To: T10 Technical Committee
From: Tim Symons, PMC-Sierra (Tim_Symons@pmc-sierra.com)
Date: 5 July 2007
Subject: 07-307r0 SAS-2 Zone group valid bit

Fix for SAS2r10 Editors Note 11

Figure 51 — One ZPSDS example

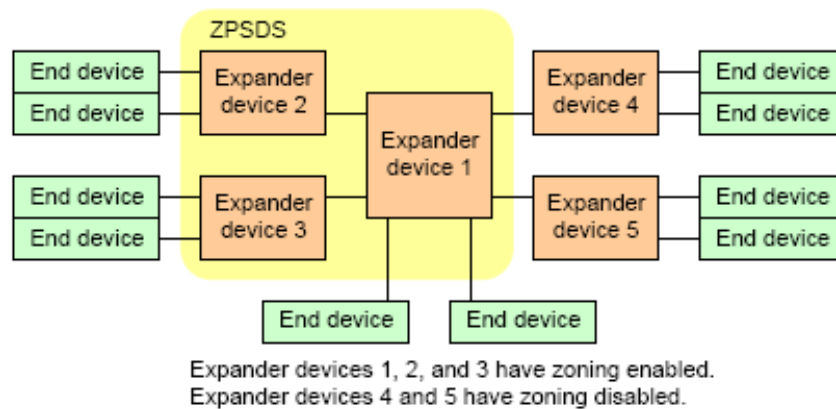
The zone route table of a zoning expander device may contain SAS address entries with the ZONE GROUP VALID bit set to zero. e.g. The zone table entries for SAS addresses of end devices attached to expander devices 4 and 5 shown in figure 51, do not have valid zone groups, because they are not attached to zoning expander devices.

The zone group of the phy on the boundary of the ZPSDS shall be asserted as the zone group for SAS addresses with the ZONE GROUP VALID bit set to zero

Figure 56 — Zoning expander route table

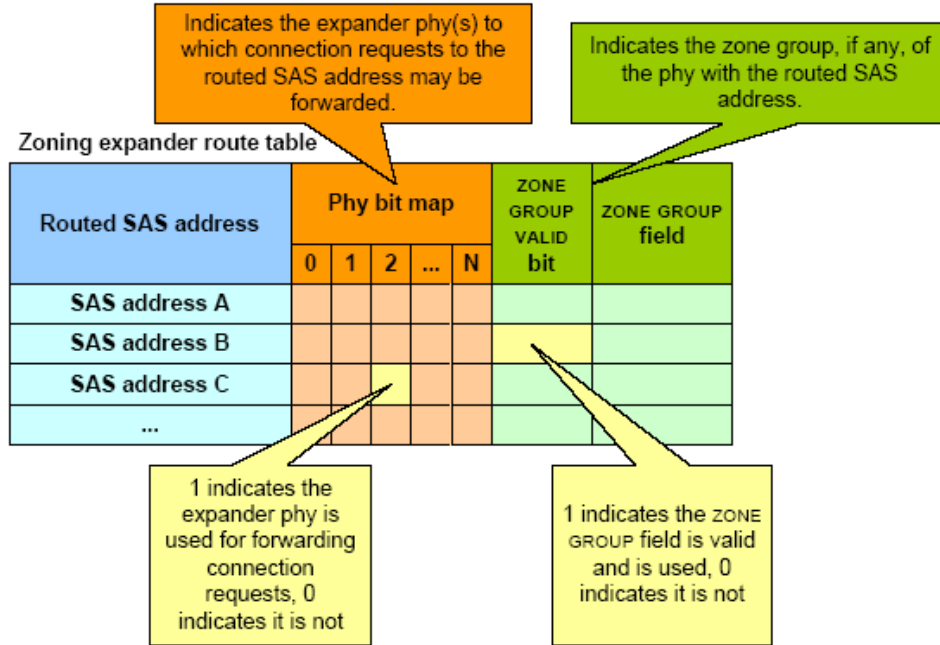
A zoning expander route table is an expander-based expander route table (see 4.6.7.3) that is able to hold the zone group of each routed SAS address.

If a SAS address is in the expander routing table and the ZONE GROUP VALID bit is set to zero, then the zone group of the destination expander phy shall be the zone group for the SAS address. If the ZONE GROUP VALID bit is set to zero and the phy is inside the ZPSDS the destination zone group shall be set to 1 and the OPEN always allowed. The zone group shall be checked by the zoning expander device at the boundary of the ZPSDS.
